LLDP Text¹: Only sections with changes are included.

Clause 79

79.3.2 Power Via MDI TLV

Figure 79-3—Power Via MDI TLV format

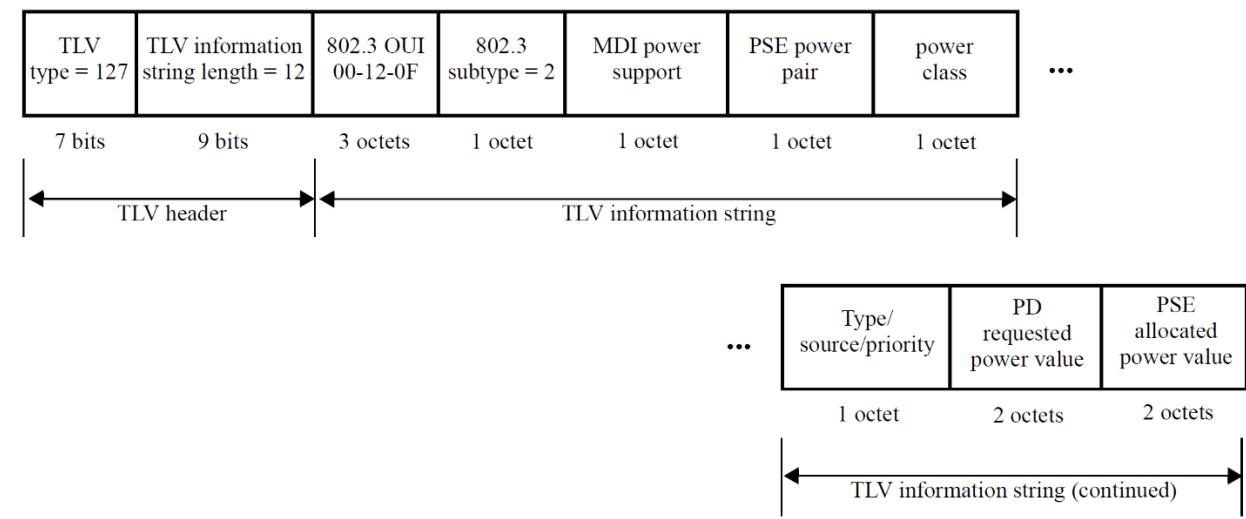
Restore Figure 79-3 from 802.3-2012, change caption to “Power via MDI TLV format for Type 1 and Type 2”

**Figure 79-3a—Power Via MDI TLV format for Type 3 and Type 4****79.3.2.5a PSE maximum available power**

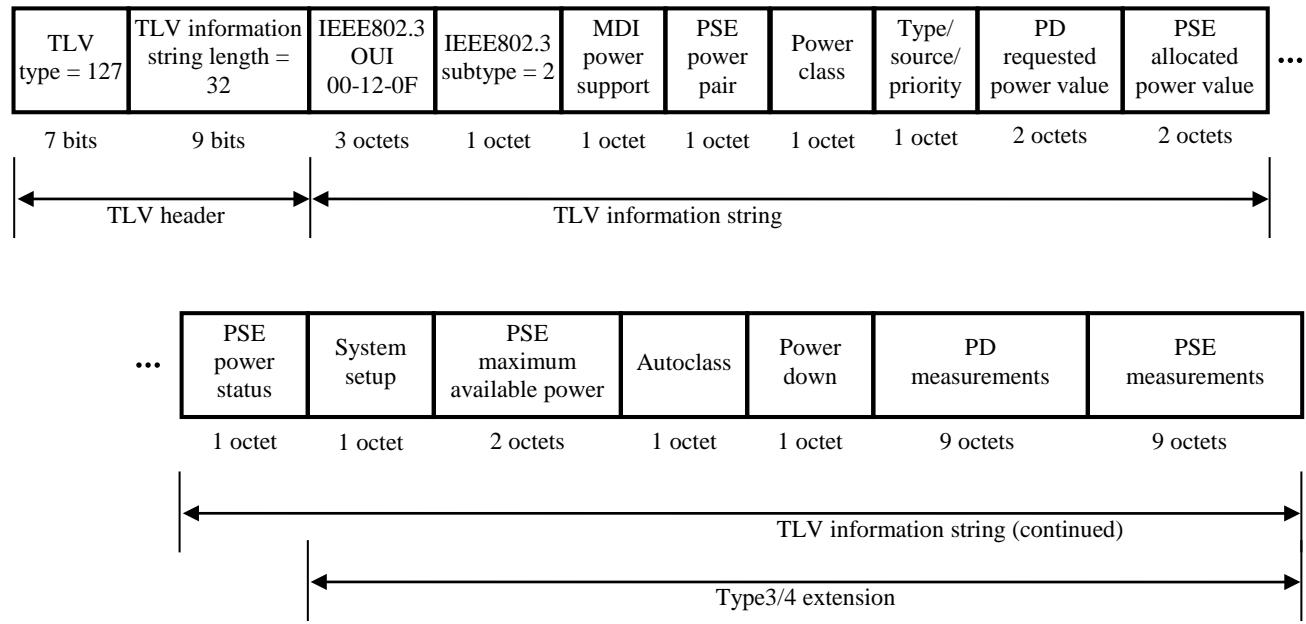
To support also long MDI TLVs a second frame size is defined as shown in Figure 79-3a
